TC1766

32-Bit Single-Chip Microcontroller

TC1766 Documentation Addendum

Revision History: **V1.2 2007-04**

Figure 11-19 Move Engine Interrupts

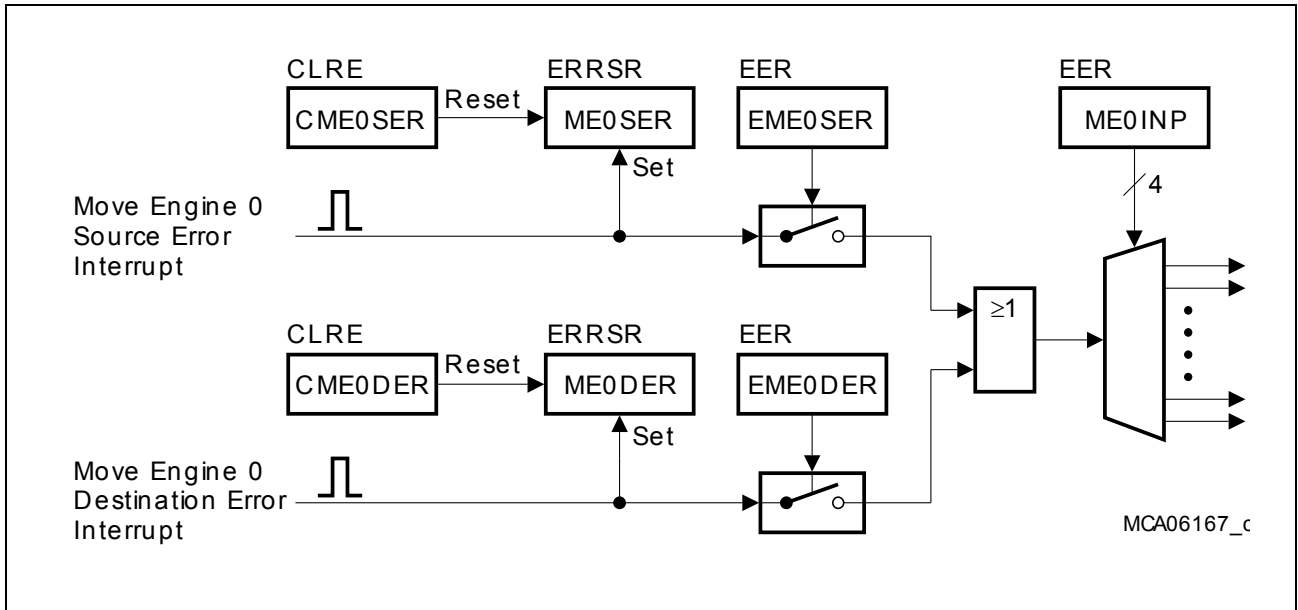
In Section 11.1.8.3, the register name EERSR must be replaced by ERRSR in the first sentence of the third paragraph and within Figure 11-19. The corresponding text must be replaced by :

Figure 11-19 must be replaced by:

“A source error of Move Engine 0 is indicated by the status flag **ERRSR.ME0SER**.”

Figure 11-29 DMA Implementation-specific Registers

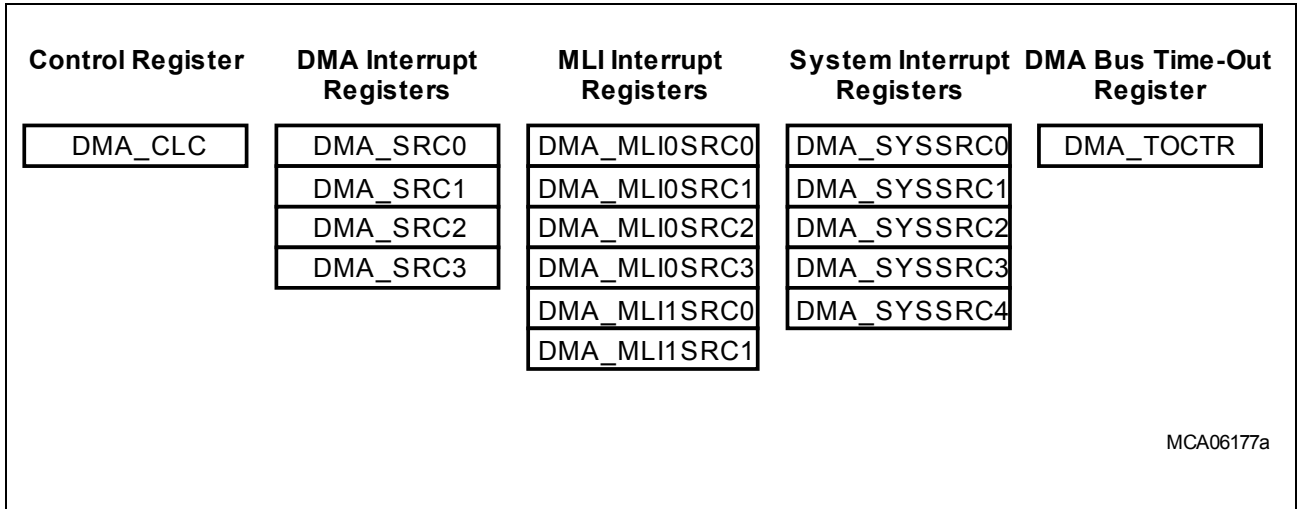
Figure 11-29 must be corrected as below:

Figure 12-5 NMI Trap Handler Routine for Parity Error Handling

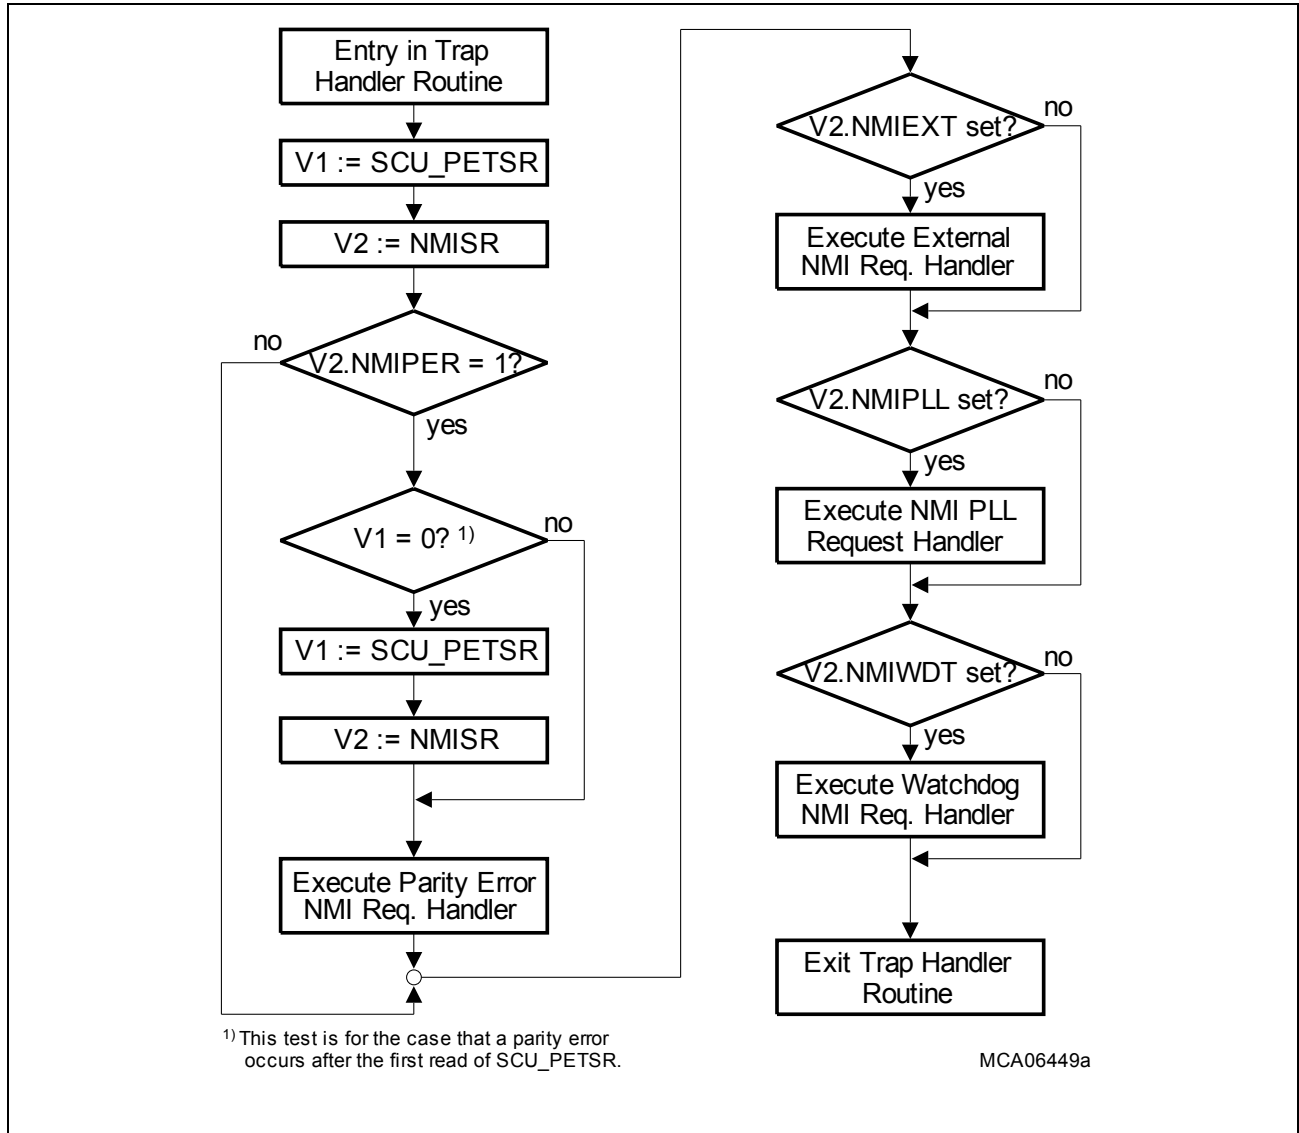
Figure 12-5 must be updated with the following corrected drawing.

Figure 17-12 ASC0/ASC1 Module Implementation and Interconnections

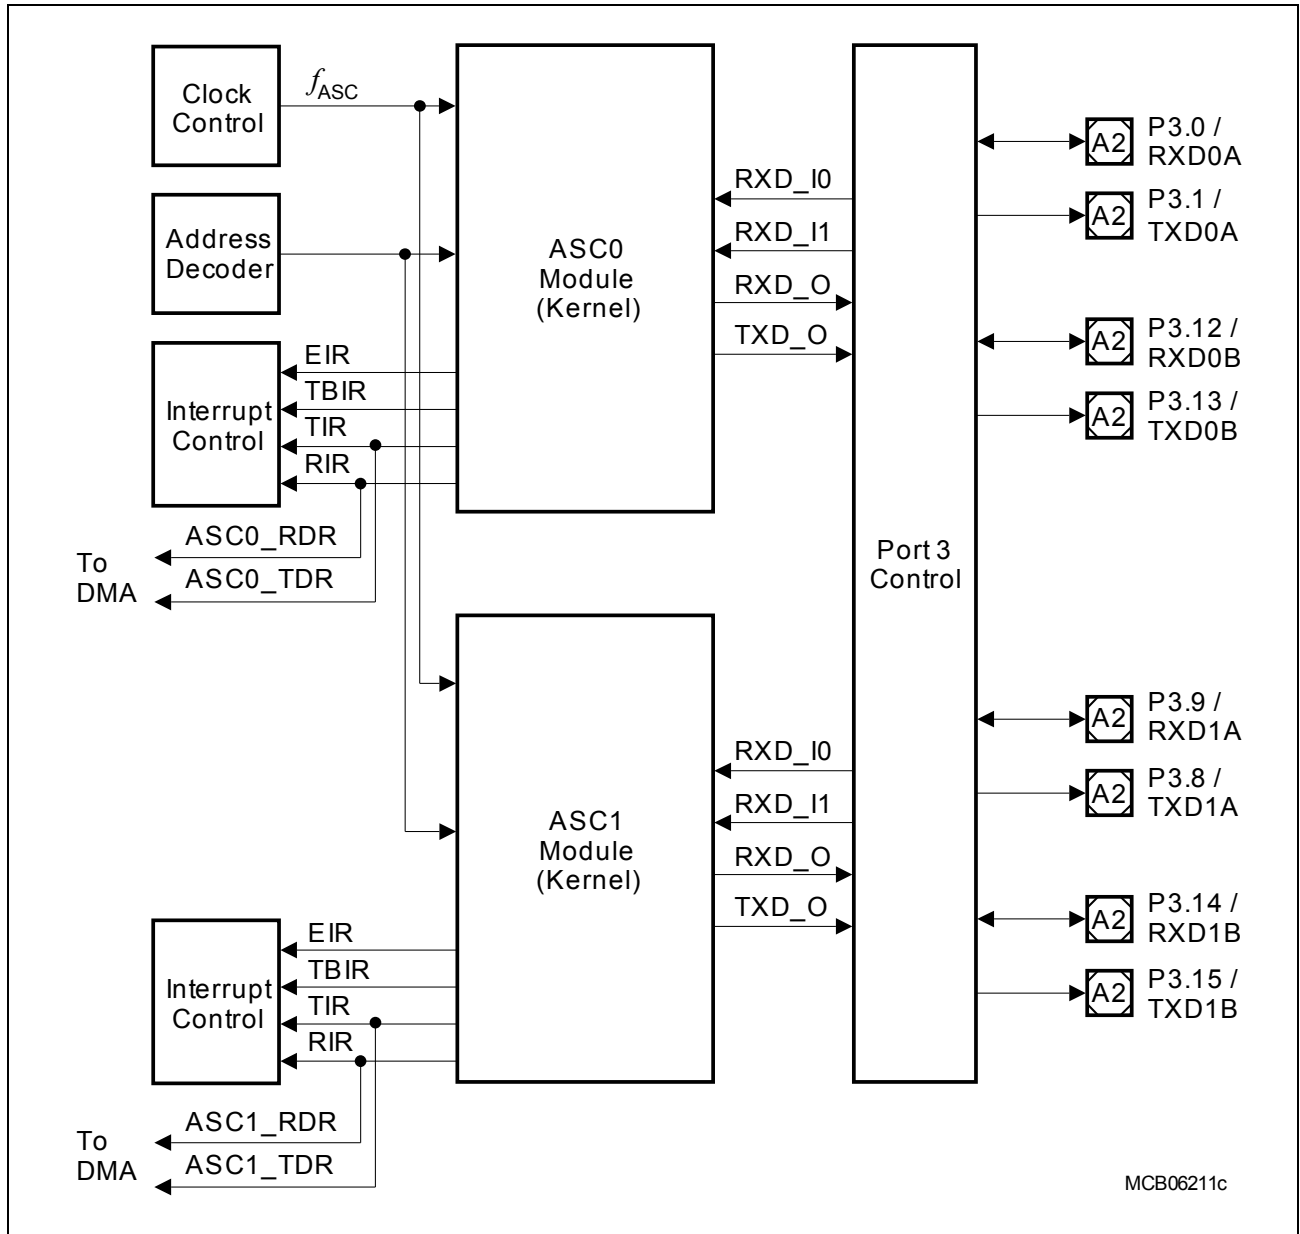
Figure 17-12 should be updated with the below figure:

Figure 18-11 SSC Error Interrupt Control

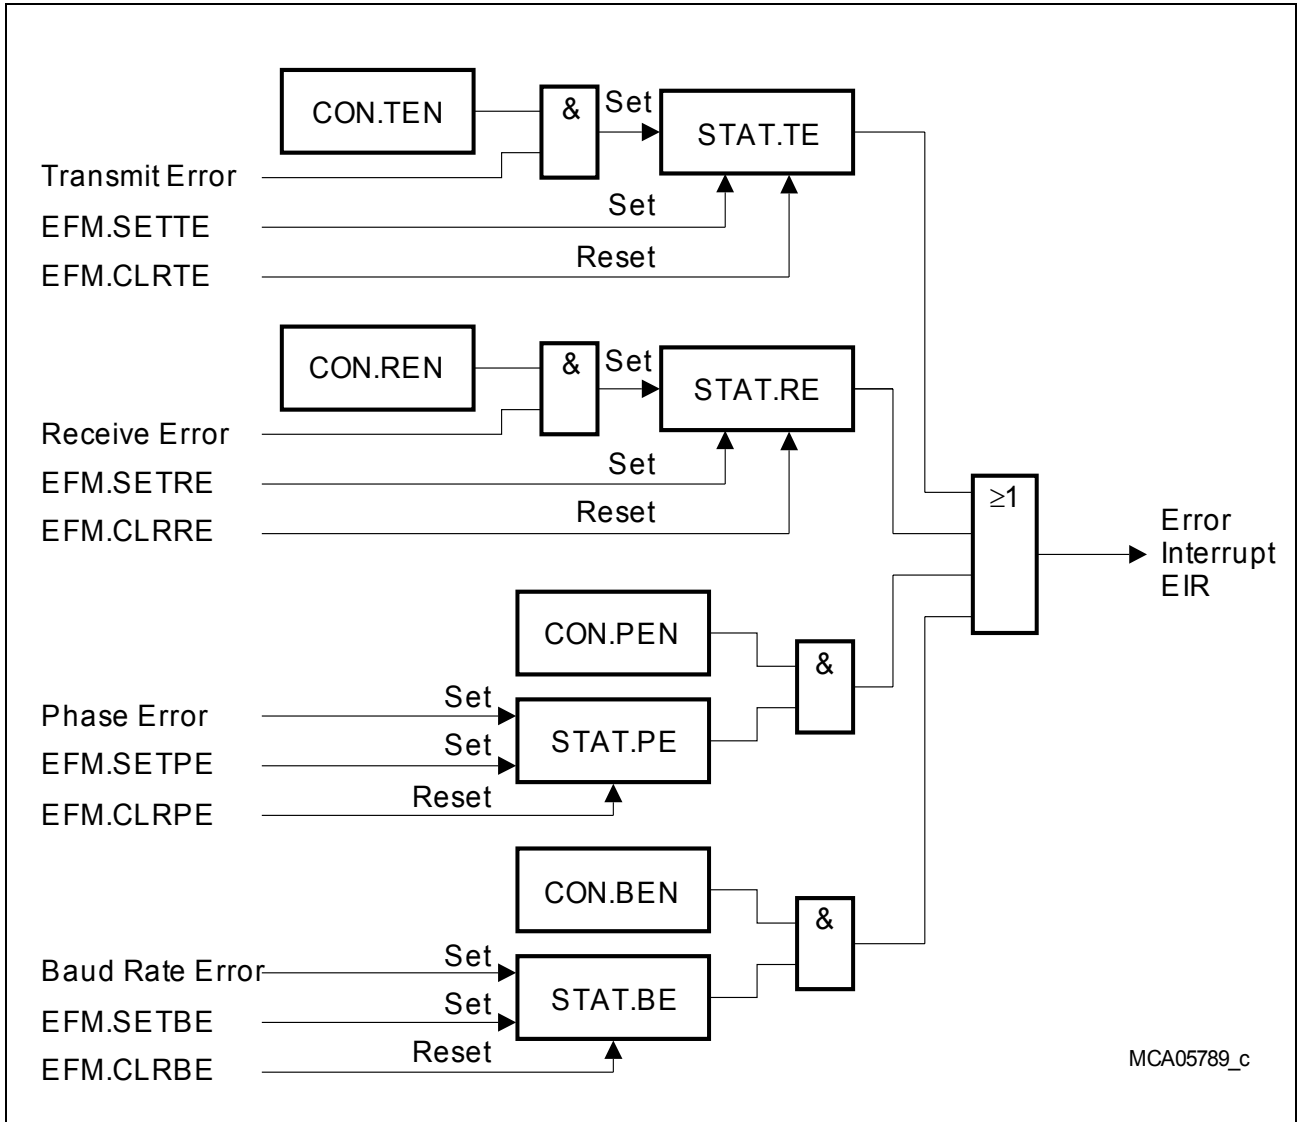
Figure 18-11 should be updated with the below figure:

Figure 20-27 Interrupt Compressor

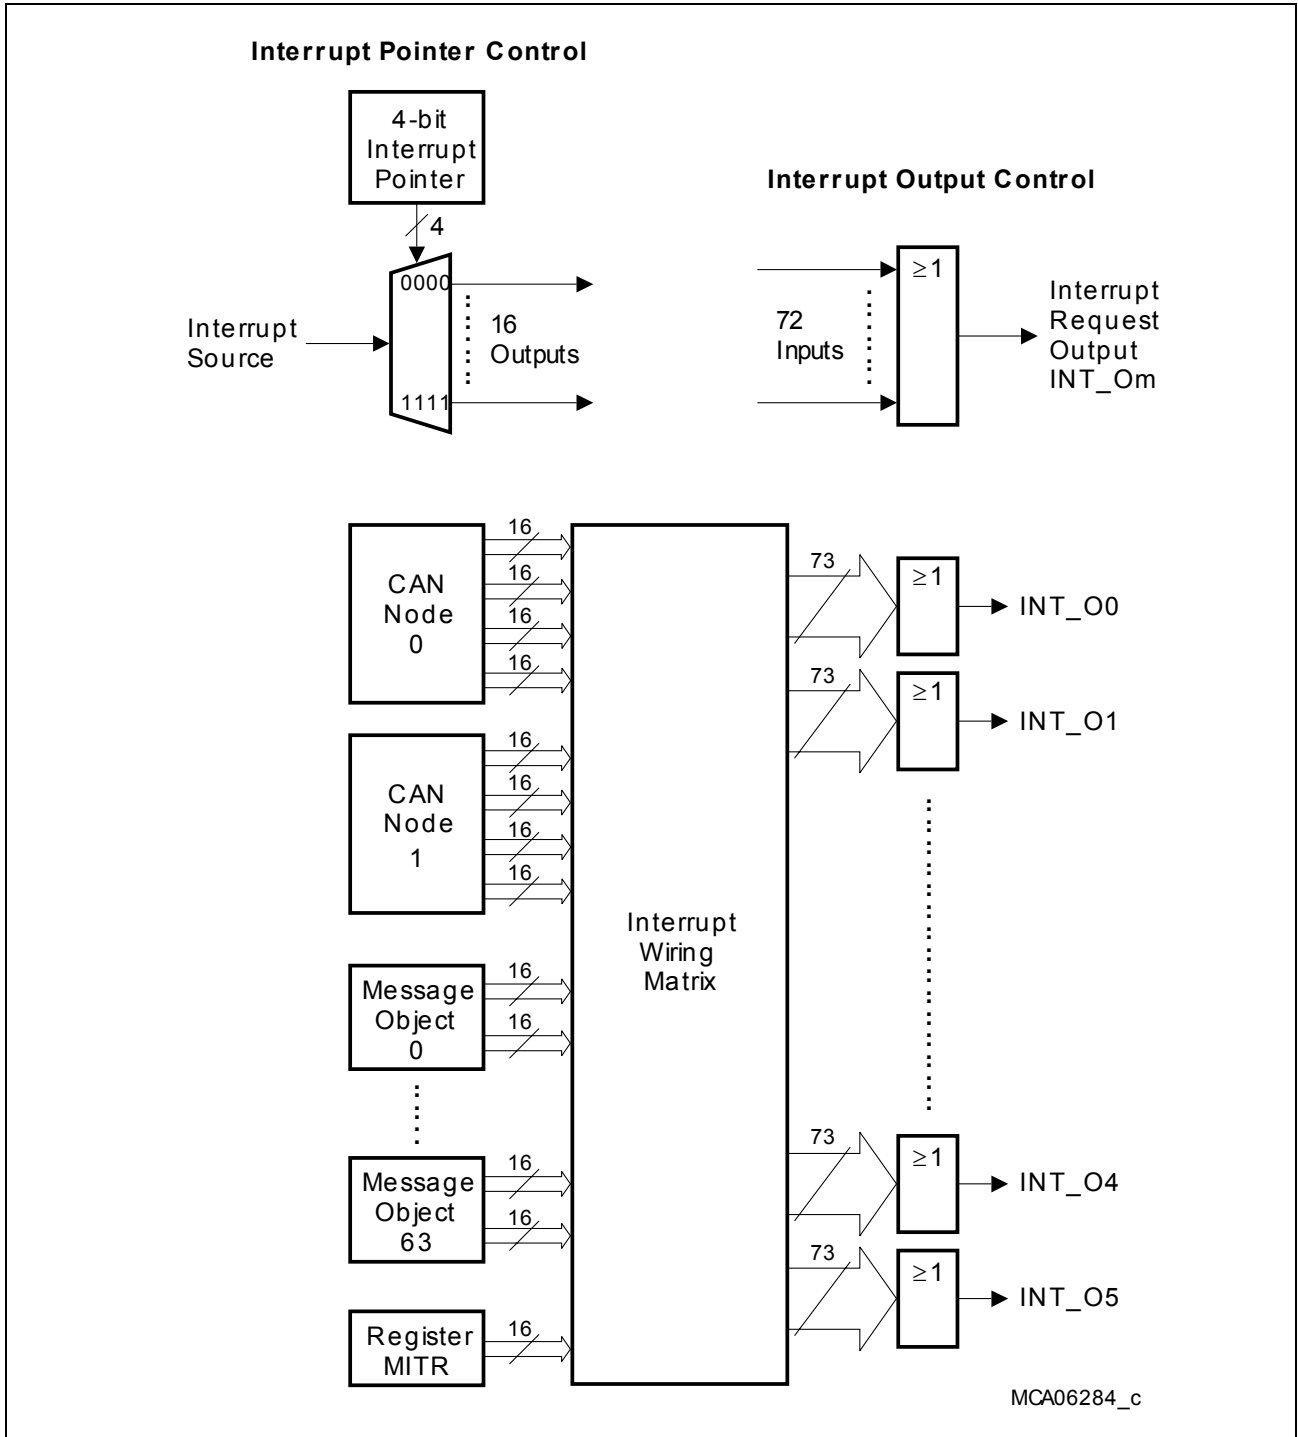
Figure 20-27 should be updated with the below figure:

Figure 22-59 Input/Output Line Sharing Unit Overview

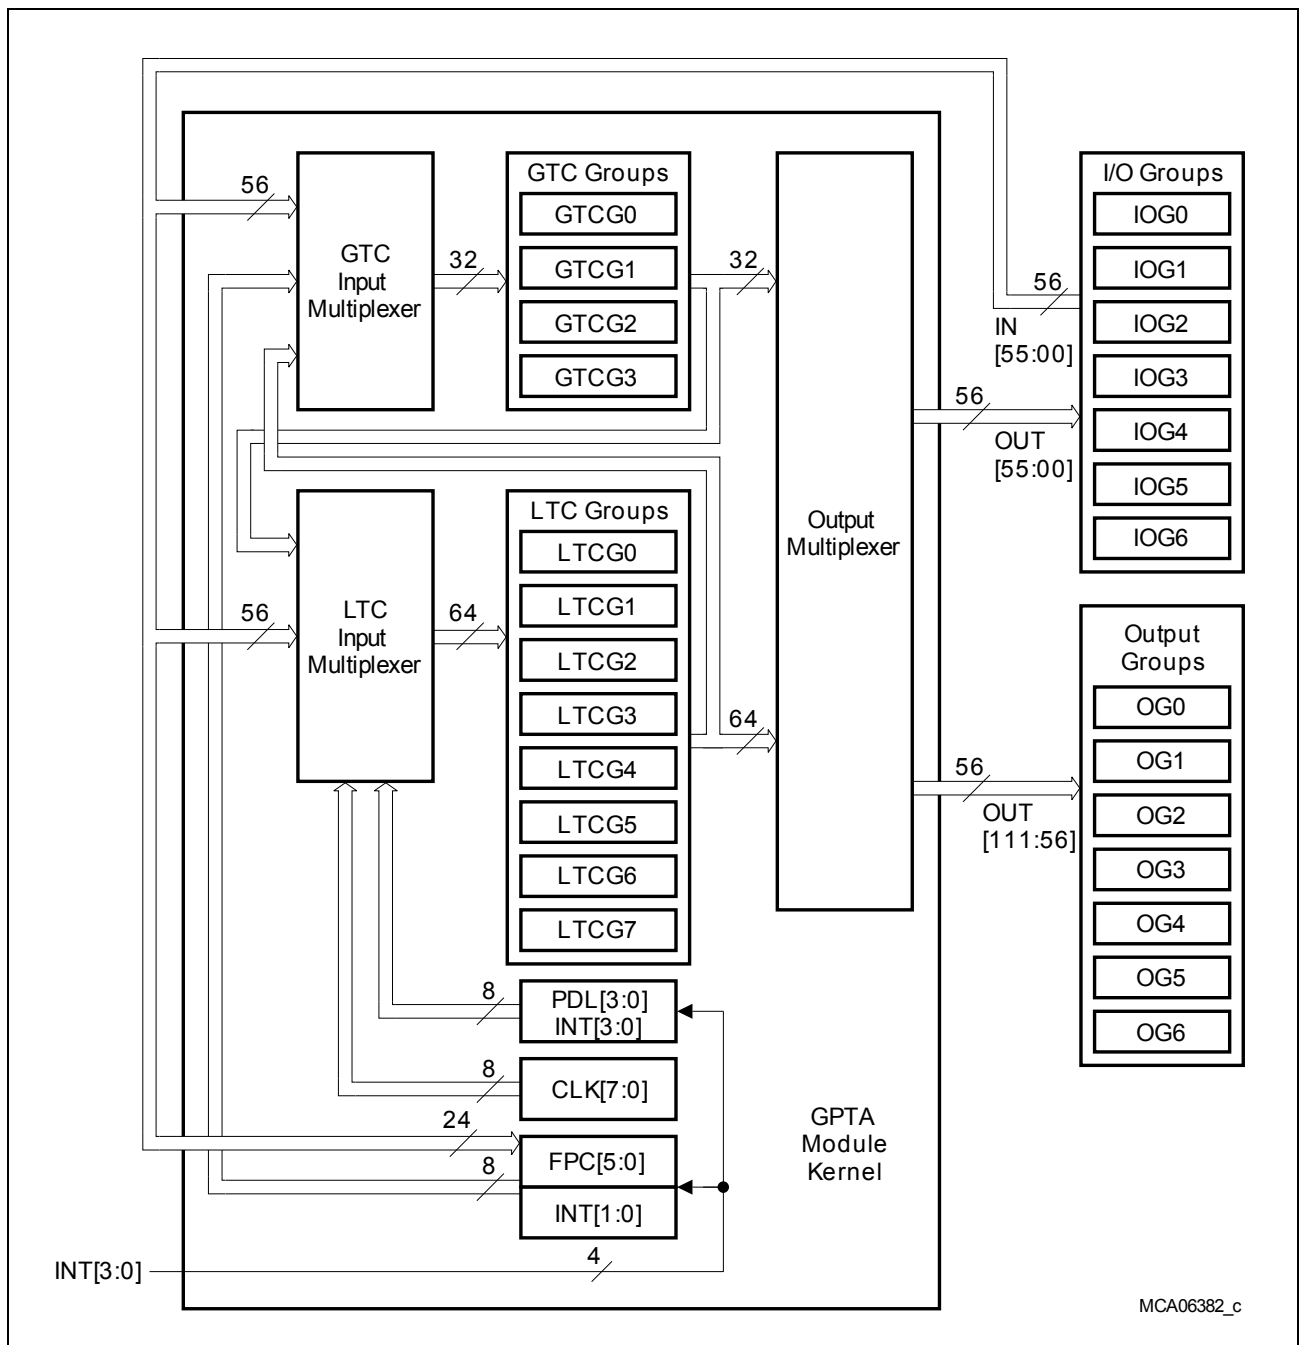
Figure 22-59 should be updated with the below figure:

Figure 22-60 Group Definitions For I/O Line Sharing Unit

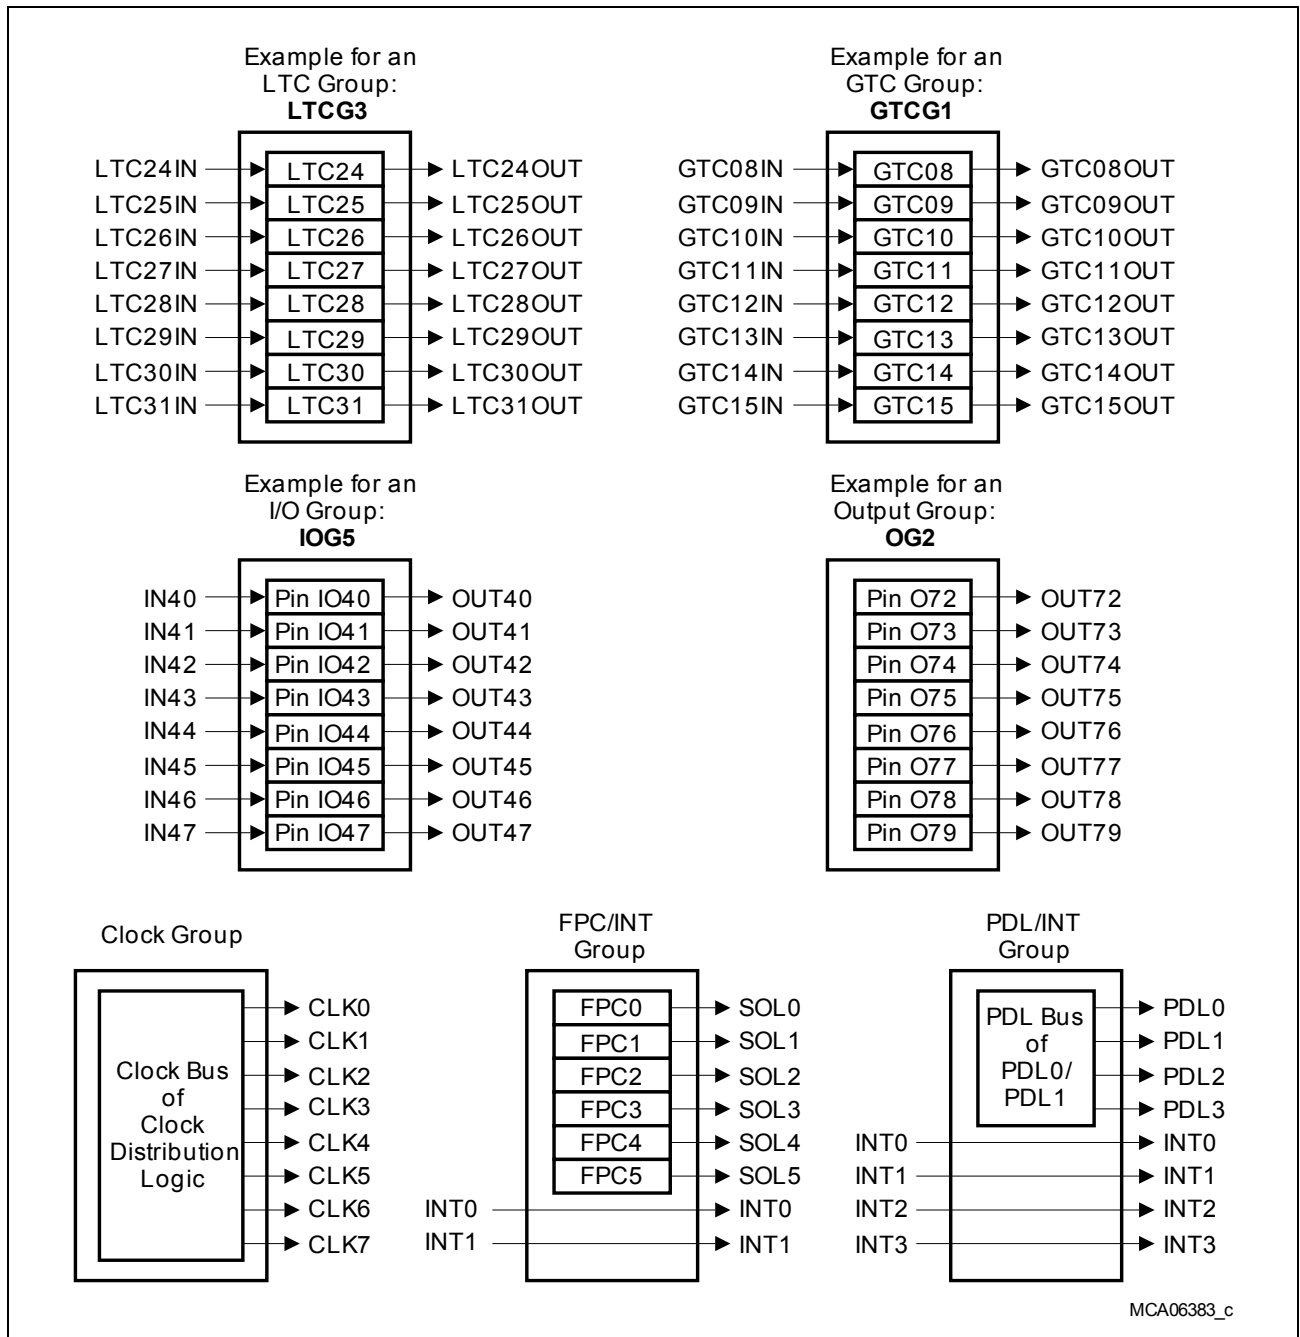
Figure 22-60 should be updated with the below figure with the example for OG2 corrected:
